[Docket No. FAA-2023-1814; Project Identifier AD-2023-00773-T; Amendment 39-22541; AD 2023-17-14]

Airworthiness Directives; The Boeing Company Airplanes

Final rule; request for comments.

Figure 1 to paragraph (h)(4) – Cap seal minimum thickness (all dimensions in inches)

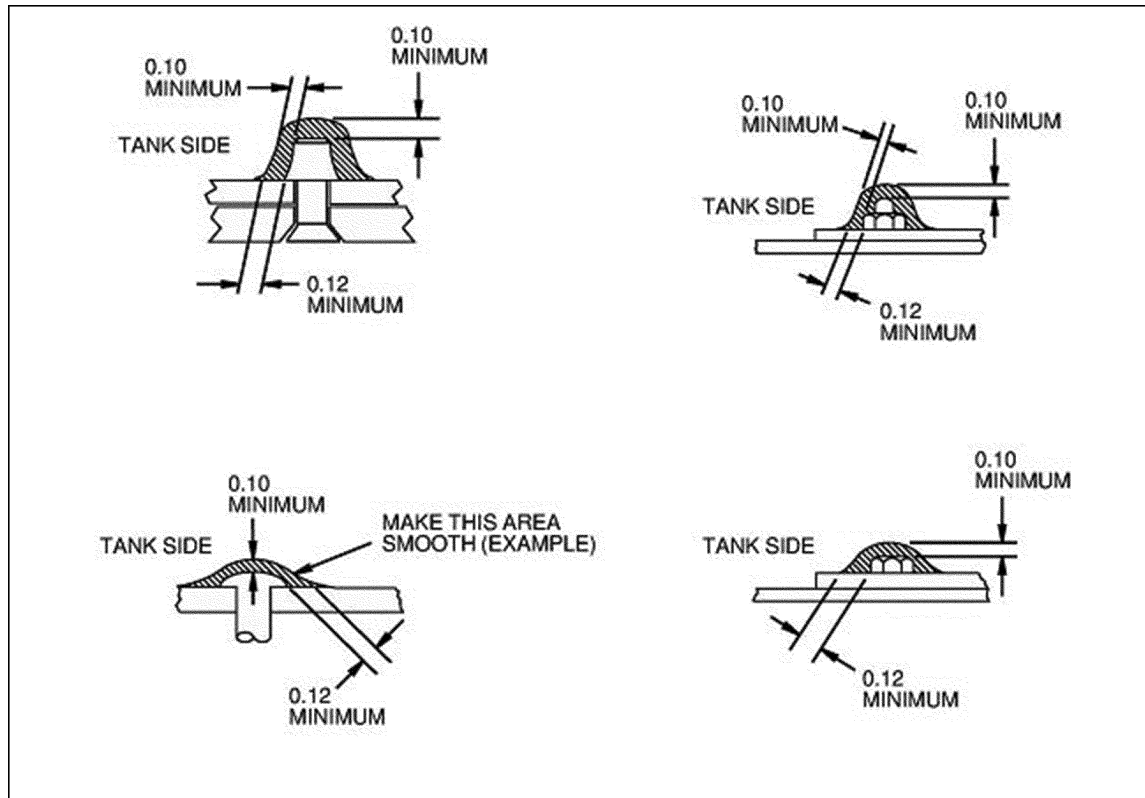
(4) During application of any cap seal to a fastener, fastener head, and fastener threads and collars, as required by this AD, the cap seal must be applied with a thickness equal to or greater than the dimensions specified in figure 1 to paragraph (h)(4) of this AD.

(6) Where Boeing Alert Requirements Bulletin 777-57A0122 RB, dated October 8, 2021, requires inspections that may require the removal of fastener cap seals, this AD requires that if the cap seal is removed, a cap seal of BMS 5-45 sealant be reapplied with a thickness equal to or greater than the dimensions specified in figure 1 to paragraph (h)(4) of this AD before further flight after completion of the inspection.

(ii) All cap seals were applied using procedures with thickness dimensions greater than or equal to those given in figure 1 to paragraph (h)(4) of this AD.

(2) If any cap seal was applied using procedures with thickness dimensions less than those given in figure 1 to paragraph (h)(4) of this AD, or if the maintenance records do not definitively specify the procedures used: At the applicable time specified in paragraph (i)(2)(i) or (ii) of this AD, replace the cap seal in accordance with the Accomplishment Instructions of Boeing Alert Requirements Bulletin 777-57A0122 RB, dated October 8, 2021, using a cap sealing procedure with thickness greater than or equal to the dimensions given in figure 1 to paragraph (h)(4) of this AD.
